## Carbon Capture Readiness (CCR) Assessment

Statera Energy Ltd

Project number: 60592577

February 2020

### Base case, per submitted report

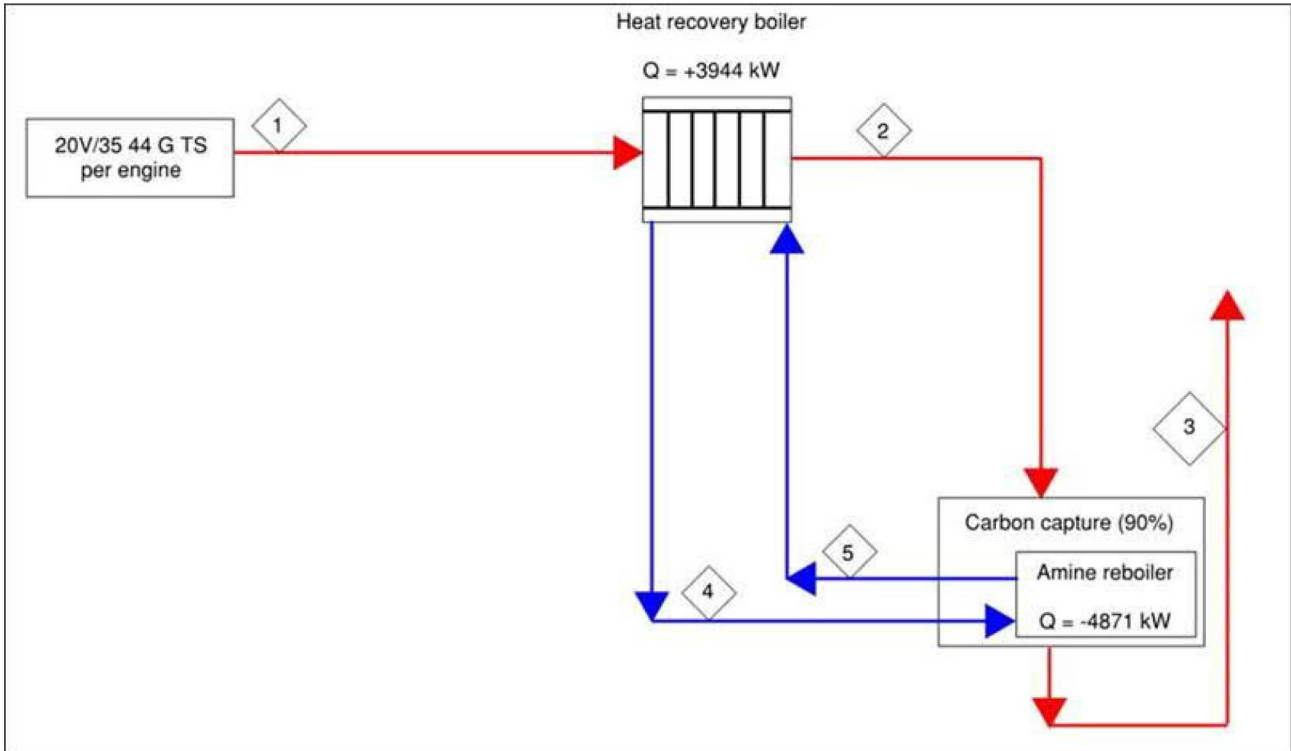
We have not gone to the detail of duct burner design beyond considering the overall requirements on a whole site and per unit basis. We expect that there is an optimum size for the duct burner and for the purposes of this preliminary study we have converged on 4 trains in total with a bank of 48/4 = 12 engines per train.

We are updating the plant layout to show legend and bubble numbers for the main plant items. In table 4.1

We have been advised that the engines are likely to be operated between 2000-3000 hrs per year.

In contrast, a balance of heat recovery from the exhaust flue gas shows only 3944 kW is available (between streams 1 and 2), further recovery would not be practical as the temperature of the gas outlet (Stream 2, 115°C) approaches that of the condensate supply (Stream 5, 111°C).
